**ARGYLL AND BUTE COUNCIL
LOCAL REVIEW BODY (LRB)**

17/0005/LRB

**Amendment to Condition 4 of Planning Permission in Principle
17/00493/PP granted on 02/05/17 (requirement for surfacing in a
bituminous surface to a point 10 metres south of the access into
the site)**

**FURTHER INFORMATION REQUESTED FROM PLANNING
AUTHORITY RELATIVE TO 17/0005/LRB**

Location Plan

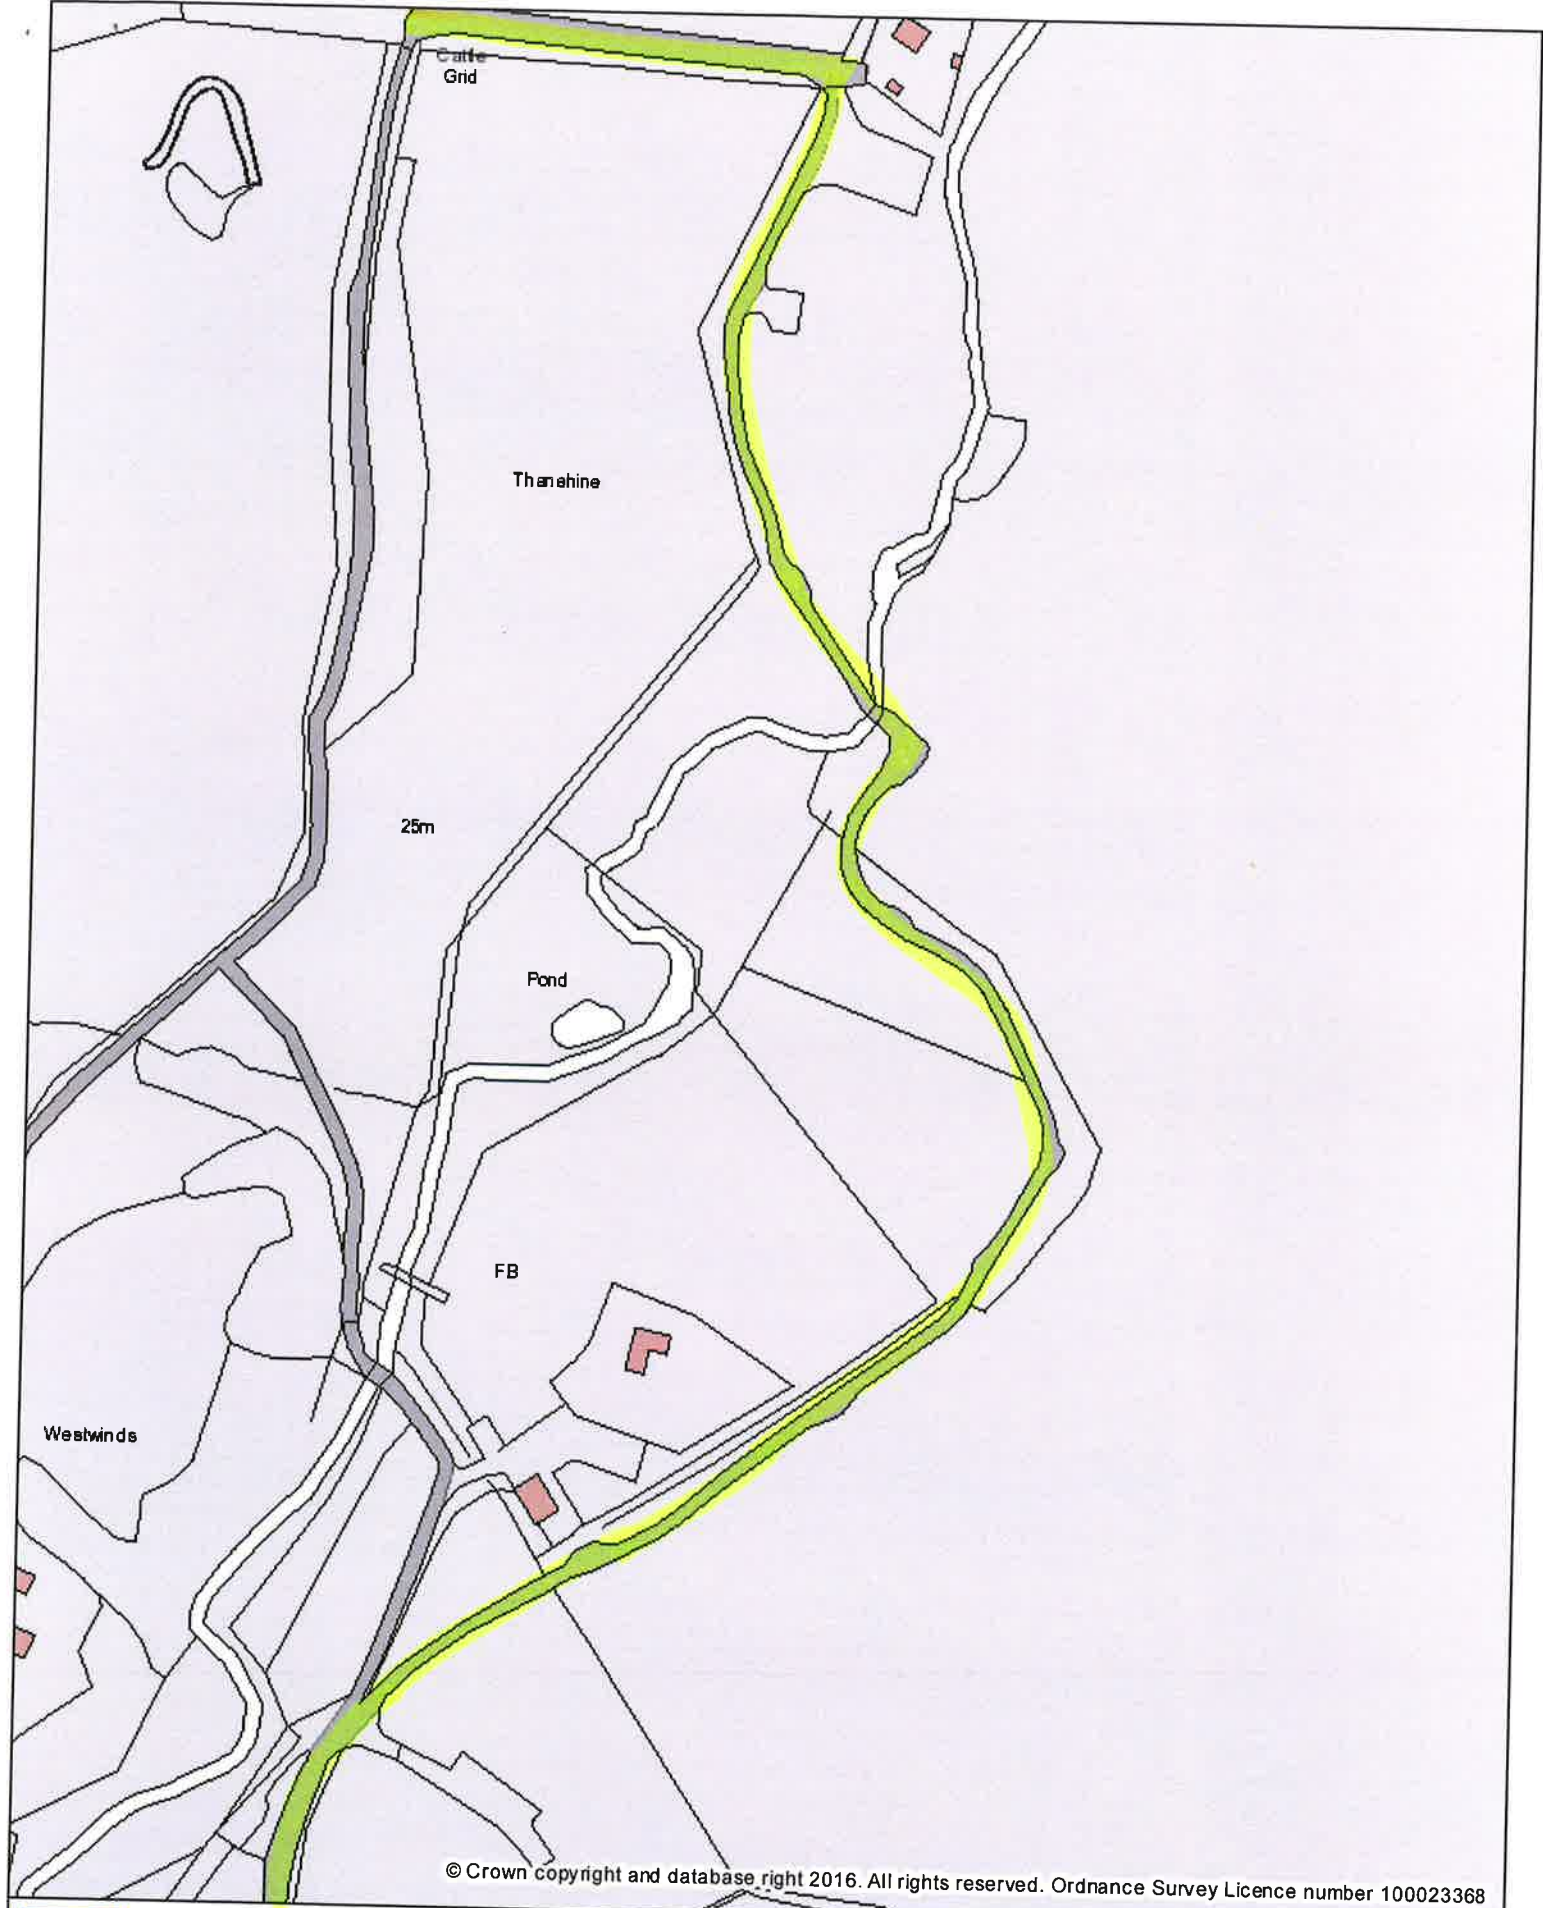
- i) To provide clarity as to the length of access to be improved as referred to in Condition 4.

Comment: The access is to be improved from its junction with the public road to a point 10 metres south of the access into the proposed development site (approximately 900 metres) – see attached plans.

EXTENT OF UPGRADE
REQUIRED BY THE ROADS
AUTHORITY

Location Plan

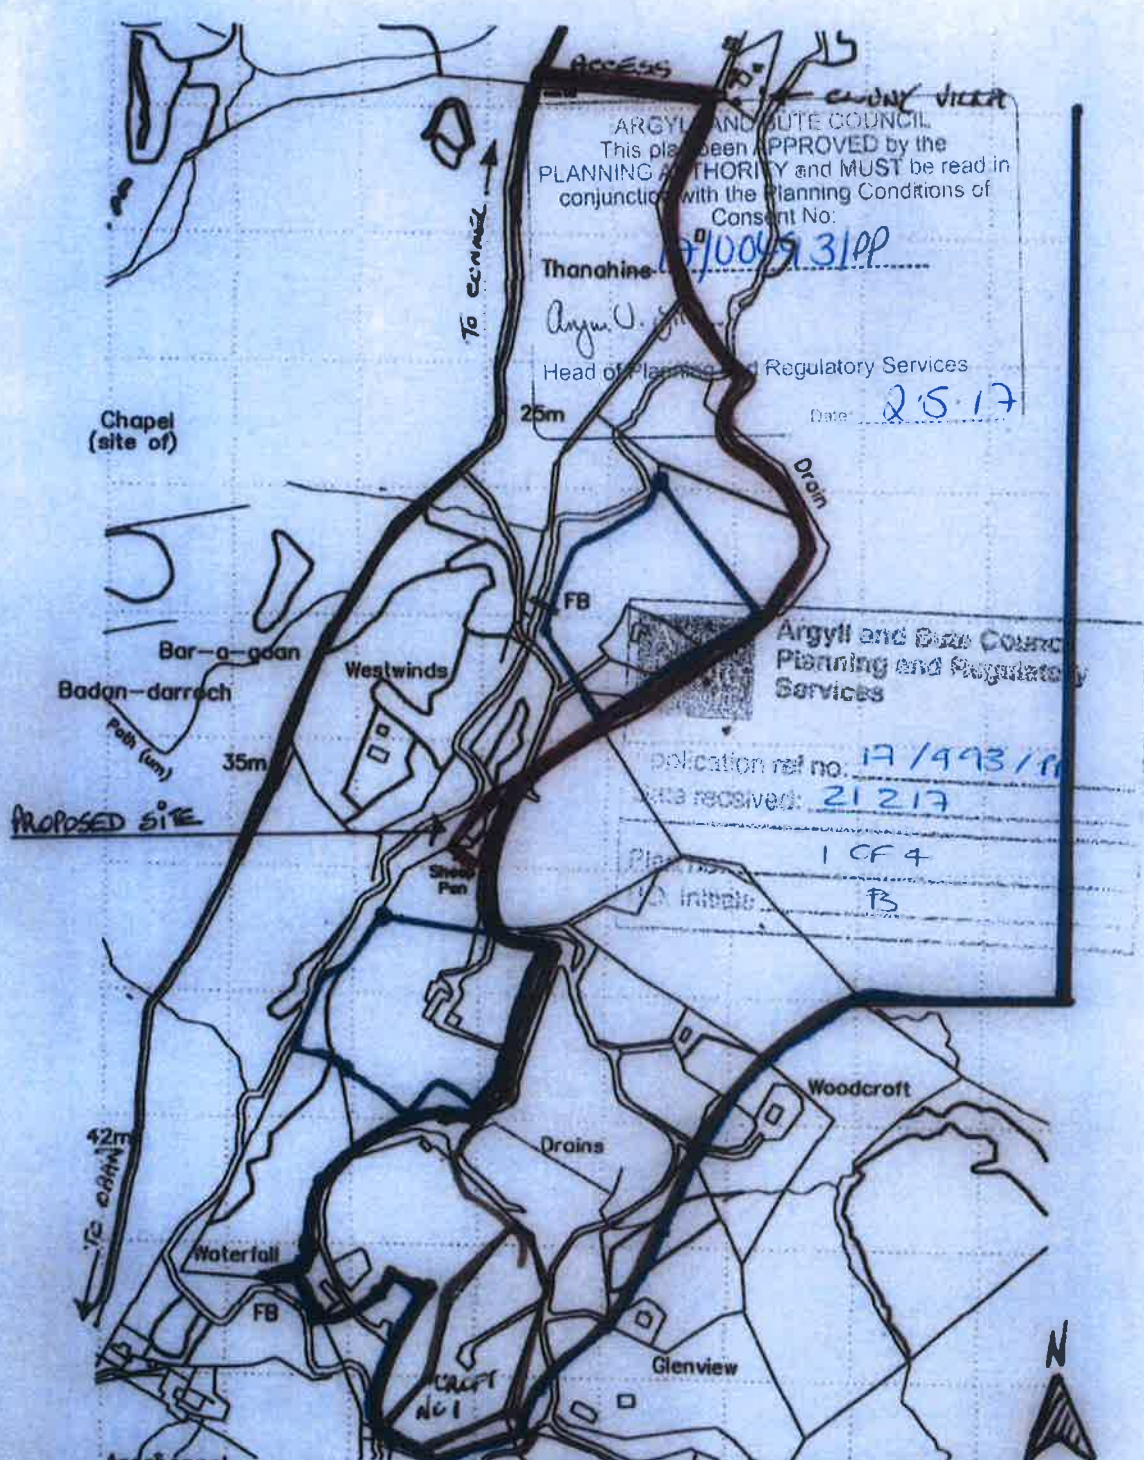
iv) To provide confirmation of land ownership in respect of the roadway and adjacent landholdings in so far as can be established.

Comment: The applicant certified on the application form that he owns the extent of the road which the Roads Authority require to be upgraded. The drawings show all land outlined in red and blue on the application drawings within the applicants ownership (see attached location plan). The Planning Service cannot advise on the ownership of any land outwith these boundaries.
